Pilot Region-Based Optimization Program for Fund-Lead Sites in EPA Region 3

Site Optimization Tracker: Greenwood Chemical Site Newtown, Virginia

EPA 542-R-06-006d
December 2006
www.epa.gov

SECTION 1:
CURRENT SITE INFORMATION FORM

FIGURE 1-1. THE GREENWOOD CHEMICAL SITE AND WELL LOCATIONS.

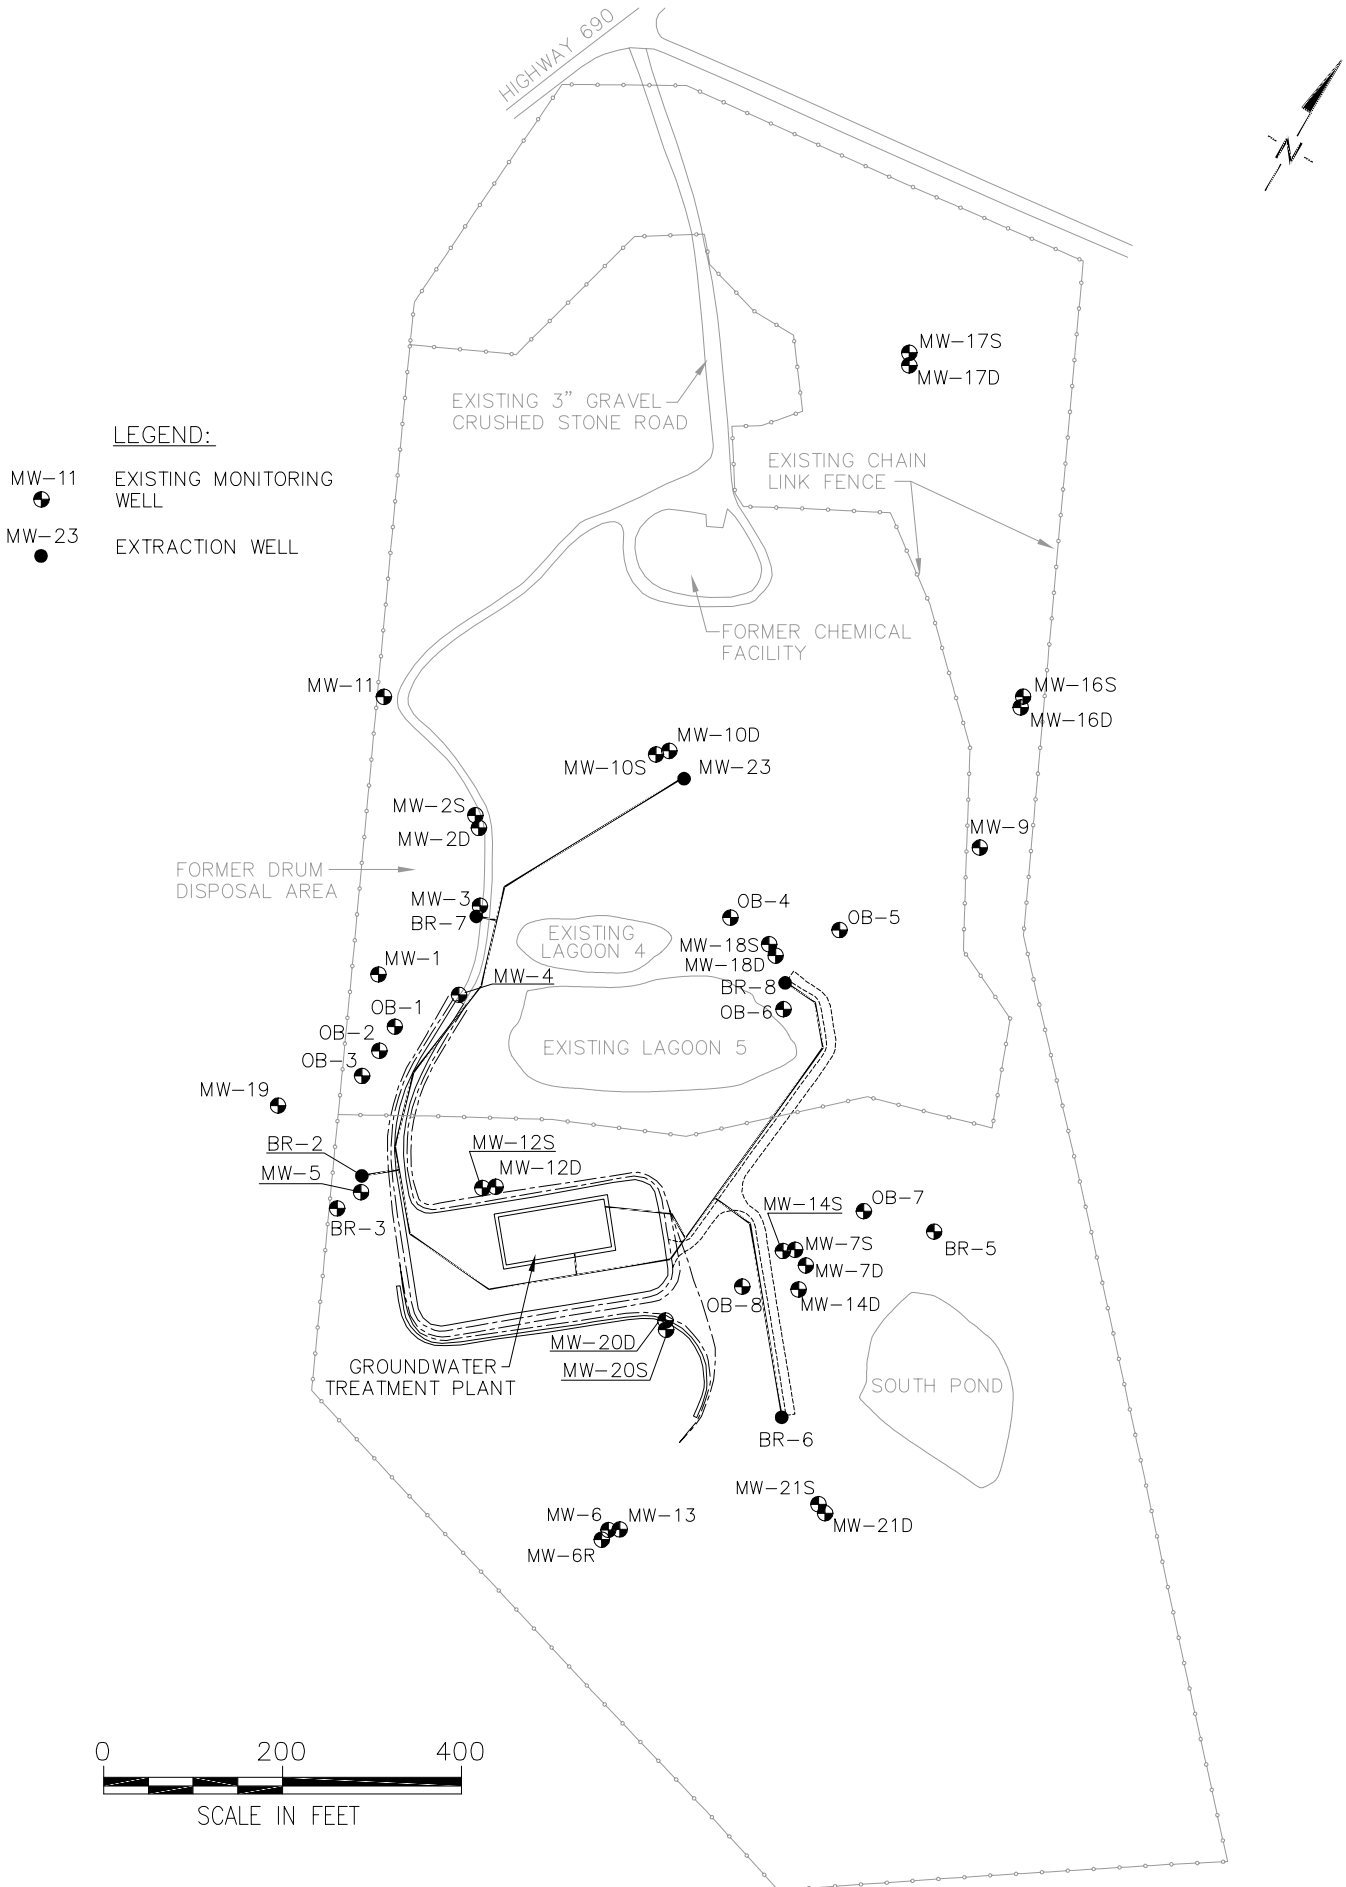
The ground water extraction system recovers ground water from five bedrock extraction wells (BR-2, BR-6, BR-7, BR-8, and MW-23) that are depicted in Figure 1-1. Each well is piped to the plant separately with a flow meter on each line. In addition, a floating pump assembly allows for extraction from Lagoon 5 (Lagoon 4 is hydraulically connected to Lagoon 5) to prevent overflow during precipitation events. The treatment system provides for metals and solids removal, destruction of organic contaminants via UV oxidation, and sorption of remaining organic contaminants to GAC. Treated effluent is discharged to the West Branch of Stockton Creek, located south of the site.

FIGURE 1-2. EXTENT OF VOC CONTAMINATION.

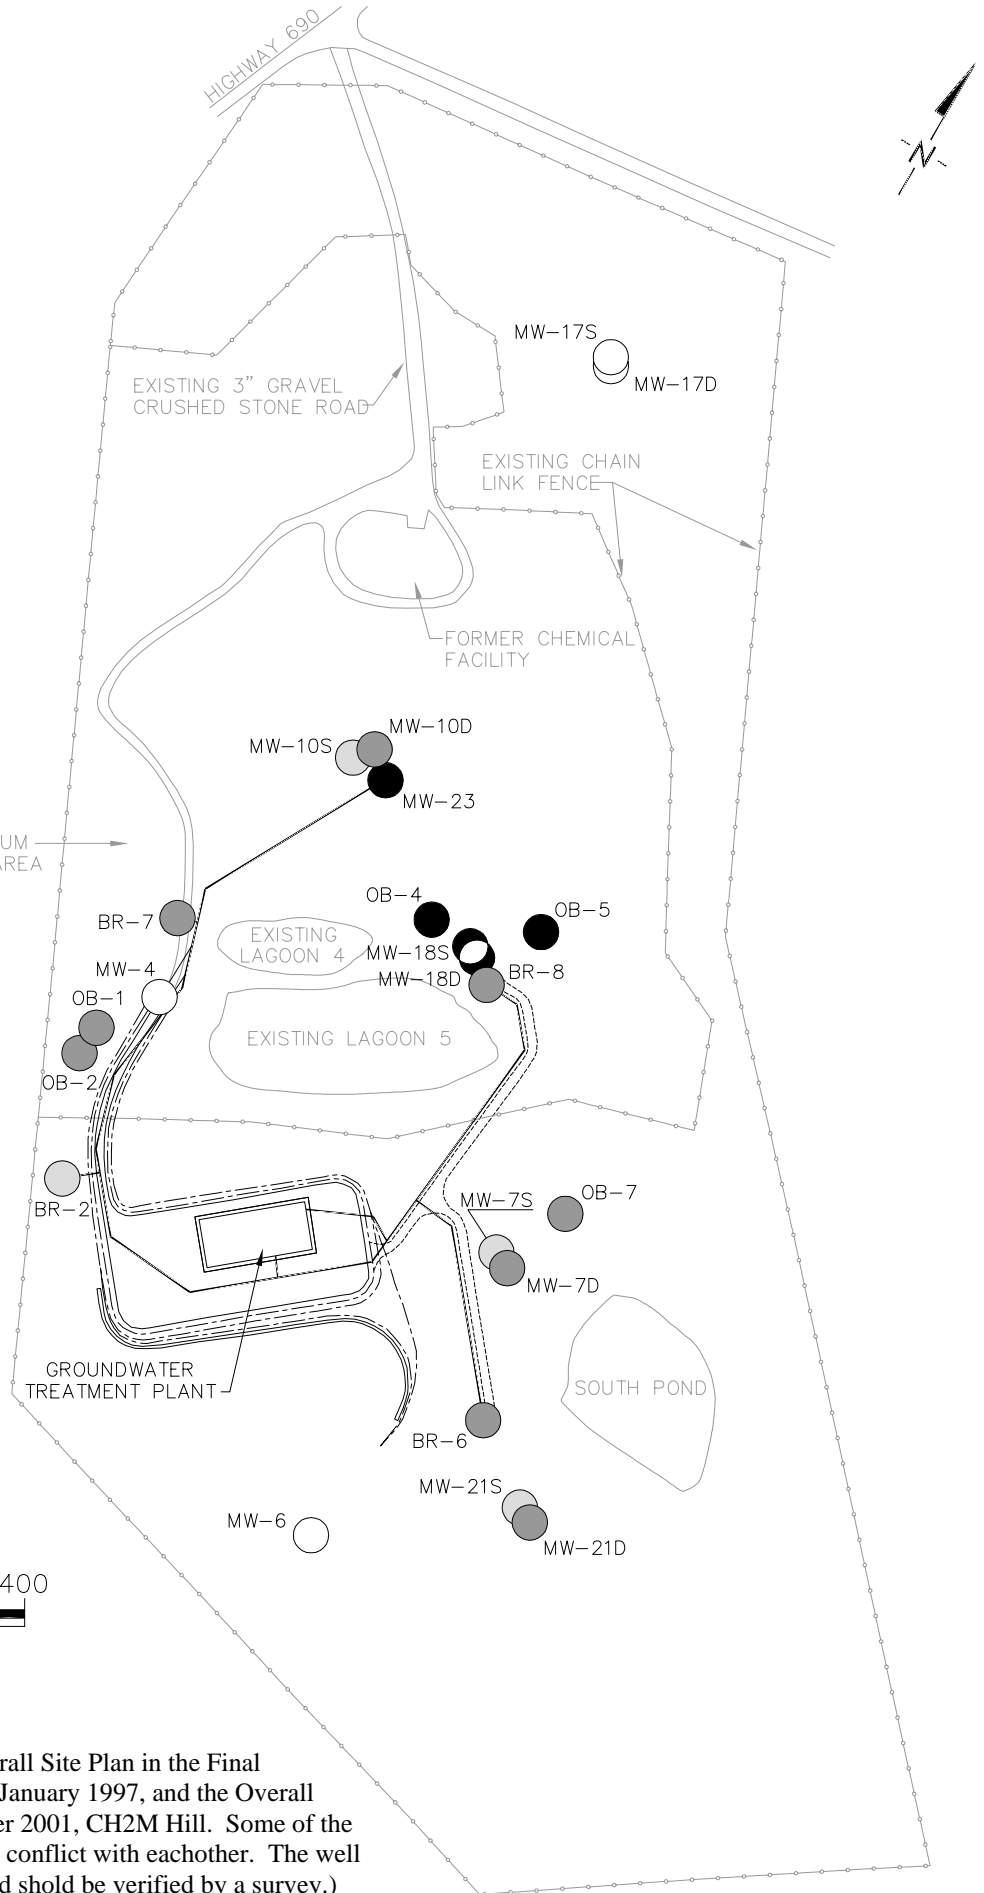
The contaminants of concern at the site are primarily VOCs, SVOCs, and metals. The VOC ground water data from September 2002 through June 2003 are shown in Tables 1-1 and 1-2 and VOCs are depicted on Figure 1-2. SVOCs, inorganic compounds, and tentatively identified compounds are not shown. Ground water quality data are not routinely tabulated as part of the site activities. Tables 1-1 and 1-2 were compiled by the optimization support team to provide the basis for analysis in this report. These data have been reviewed and are of sufficient quality for use in this report, but the optimization support team recommends that these data be thoroughly reviewed using a more rigorous QA/QC protocol.

At this site, the plume has not been fully delineated and a target capture zone has not been established. As indicated in Figure 1-2, contamination is present above site-specific standards (and above MCLs) at MW-21S and MW-21D. Contamination (albeit at low concentrations) is also present in BR-2, which is an extraction well that marks the furthest downgradient sampling point (in recent sampling events) on the western side of the property. Many of the deep wells at the site also have contamination with no deeper wells to provide delineation. MW-7D and MW-21D are examples of such wells. The concentrations at MW-7D and MW-21D are higher than at MW-7S and MW-21S (respectively), and it is possible that concentrations below MW-7D and MW-21D might actually increase with depth. The MW-14 cluster, which is adjacent to the MW-7 cluster, has bedrock wells which are deeper than those of the MW-7 cluster, but the sampling data from the past year (4 quarters) indicate that the MW-14 cluster has not been sampled.

We recommend installing additional monitoring wells for delineation. Two clusters of monitoring wells at three depths should be installed downgradient of MW-21D (perhaps 200 to 400 feet downgradient depending on accessibility). The shallow and intermediate wells in each of these clusters might be completed to depths that are comparable to MW-21S and MW-21D. The depths of the deeper wells in each of the clusters would likely need to be determined in the field, but sampling MW-14D prior to the drilling event may provide useful information. MW-14D is located approximately 200 feet upgradient of MW-21D but the elevation of the base of the screen for MW-14D is 140 feet deeper than that of MW-21D. The data reviewed by the OSE team suggested that MW-14D has not been sampled recently. Depending on the results from MW-14D, the site team might consider drilling to a depth of 100 to 200
